SWD - 1667
 - Mesquite SWD #1
 30-015-pending well
 + Sandstone SWD #2
 30-015-pending

APPLICATION FOR AUTHORIZATION TO INJECT

Mesquite SWD, Inc.
 Sand Dunes SWD #2
 2600' FSL & 2500' FWL
 Sec. 8, T24S-R31E Eddy County, NM

From: McMillan, Michael, EMNRD
Sent: Friday, February 24, 2017 9:12 AM
To: 'mjp1692@gmail.com'
Cc: Riley Neatherlin; Bratcher, Mike, EMNRD; Inge, Richard, EMNRD; 'Swartz, Paul'; James Glover ; Lisa Lemon ; Podany, Raymond, EMNRD; Sharp, Karen, EMNRD; Jones, William V, EMNRD; Brown, Maxey G, EMNRD; Whitaker, Mark A, EMNRD; Goetze, Phillip, EMNRD; Lowe, Leonard, EMNRD
Subject: SWD-1667 Mesquite SWD Inc. Sand Dunes SWD Well No. 2 Eddy County API 30-015-pending

PROPOSED NEW WELL DIAGRAM

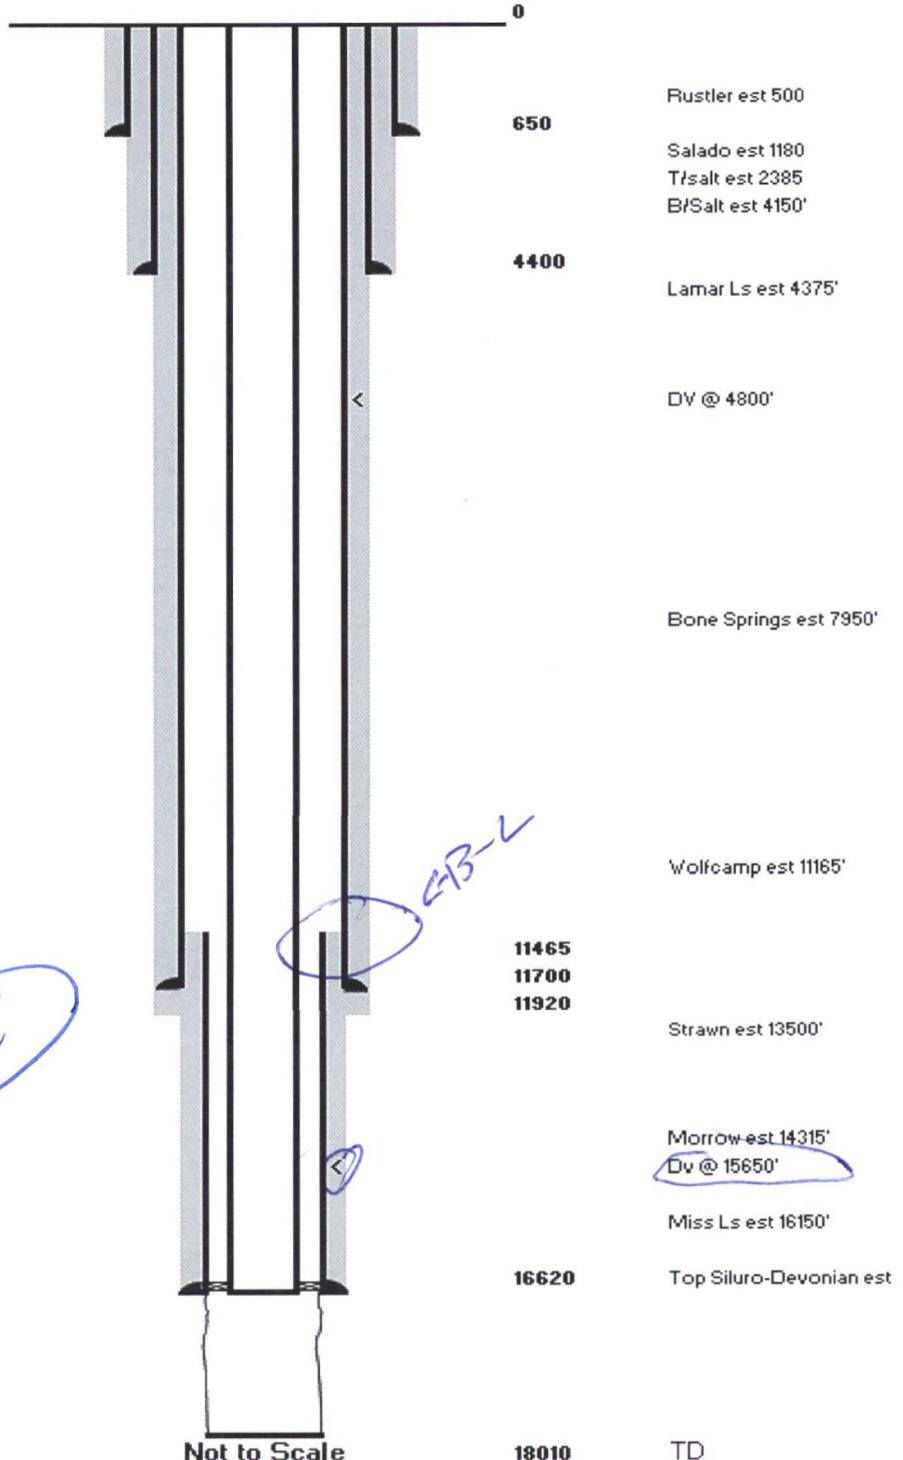
Order Conditions: Issues: 24W C-B-L from 11000' - 16620' (on liner - TRP Lines)

The OCD has received your requests on several disposal wells to use 5-1/2 inch EUE pipe as tubing installed inside 7-5/8 inch cemented casing or liner.

After all considerations, the OCD is respectively denying the use of this tubing as proposed.

Please review the order for any additional requirements that may have been included as conditions for approval. **The Maximum allowed tubing size shall be no greater than 4-1/2 inches.**

Please plan to install a maximum of 4-1/2 inch tubing inside the 7-5/8 cemented casing.
